# FAMILY DOLLAR SR-12-2017

## Administrative Site Review

**Case File / Name:** SR-12-17 / Family Dollar #715478

SR-12-17 Preliminary Site Plan

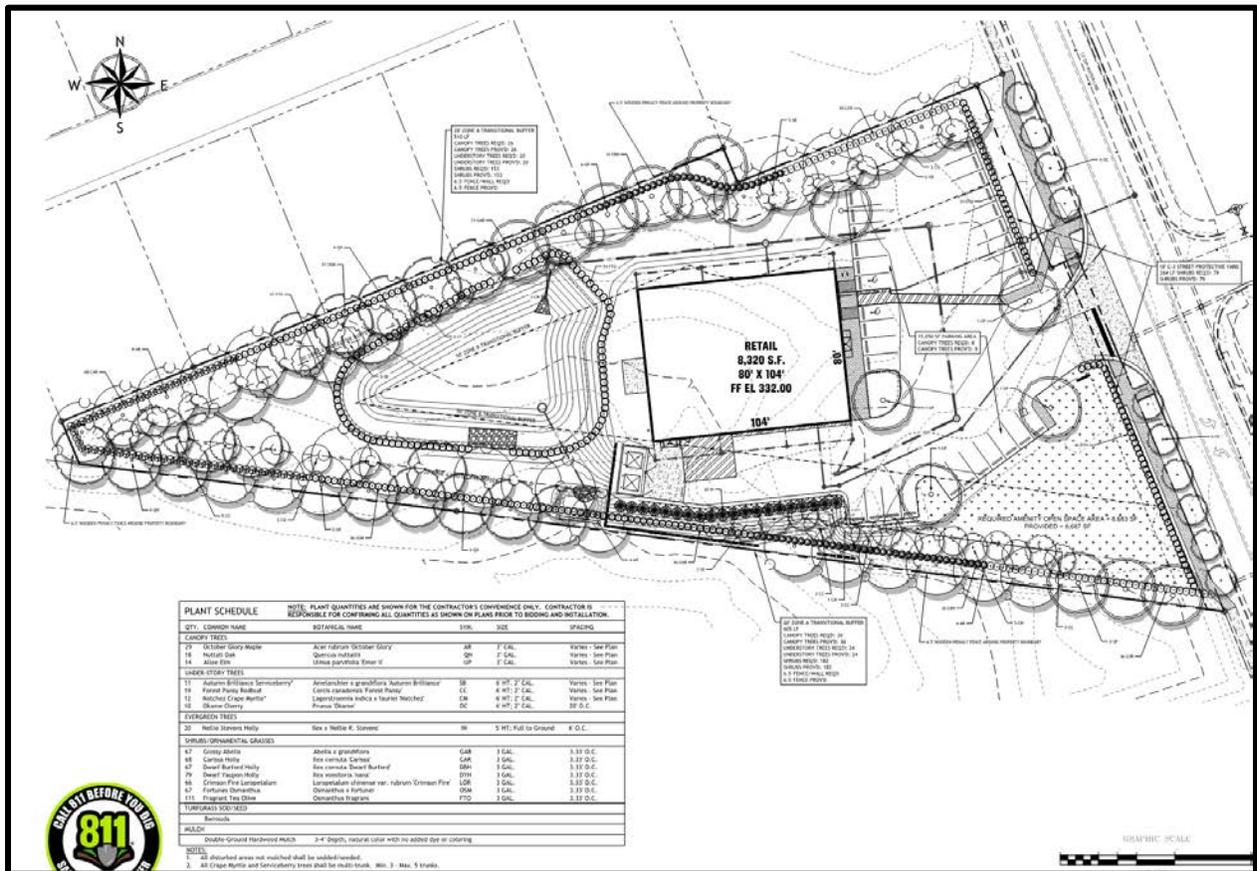
**Design Adjustment:** Due to existing infrastructure, a design adjustment was approved waiving the block perimeter requirement. (UDO Section 8.3)

Findings: Staff is in favor of the design adjustment for relief of the block perimeter requirements of UDO Section 8.3 due to the existing infrastructure and features which inhibit an additional public street connection.

**CONDITIONS OF  
APPROVAL:**

1. That in accordance with Part 10A Section 9.4.4, a surety equal to of the cost of clearing, grubbing and reseeding a site, shall be paid to the City;

2. That a demolition permit be issued;
3. That a stormwater control plan with a stormwater operations and maintenance manual and budget shall be approved by the Stormwater Engineer in compliance with Part 10A Chapter 9 of the Unified Development Ordinance, including the designation of buffer areas and open space areas for stormwater purposes prior to grading or the approval of construction drawings whichever event comes first;
4. That a nitrogen offset payment must be made to a qualifying mitigation bank;
5. That the developer shall pay to the City a stormwater facility replacement fund payment equal to twenty-four percent (24%) of the estimated cost of constructing all stormwater control facilities shown on the development plans;

6. That a recombination map be recorded prior to or in conjunction with the recording of lots, recombining the existing lots into a single tract;
7. That in accordance with Part 10A Section 9.2.2, a surety equal to 125% of the cost of the construction of a stormwater device is paid to the City;

8. That all stormwater control measures and means of transporting stormwater runoff to and from any nitrogen and stormwater runoff control measures shall be shown on all plats for recording as private drainage easements;

9. That ½ of a 76' required right of way with a 5' utility easement outside of the right of way along Garner Road is dedicated to the City of Raleigh and recorded with the Wake County Register of Deeds;

10. That in accordance with Part 10A Section 8.1.3, a surety equal to 125% of the cost of development related improvements, including streetscape trees on Garner Road is paid to the Development Services Department;

11. That a right-of-way obstruction permit is obtained from Right-of-way Services for any construction activity within the right-of-way;
12. That a Tree Impact Permit to plant new street trees on the public right-of-way must be obtained from the City of Raleigh, and that new street trees planted in the public right-of-way shall be planted and maintained in accordance with the provisions of the City Tree Manual;
13. That all proposed outdoor lighting will meet the standards of Section 7.4 of the Unified Development Ordinance;
14. That all mechanical equipment must be located and shown on the plan and meet the screening standards of section 7.2.5 of the Unified Development Ordinance;

15. That in accordance with Part 10A Section 9.2.2, an as-built plan and certification any stormwater control device shall be reviewed and accepted by the City prior to final stormwater inspection approval or certificate;
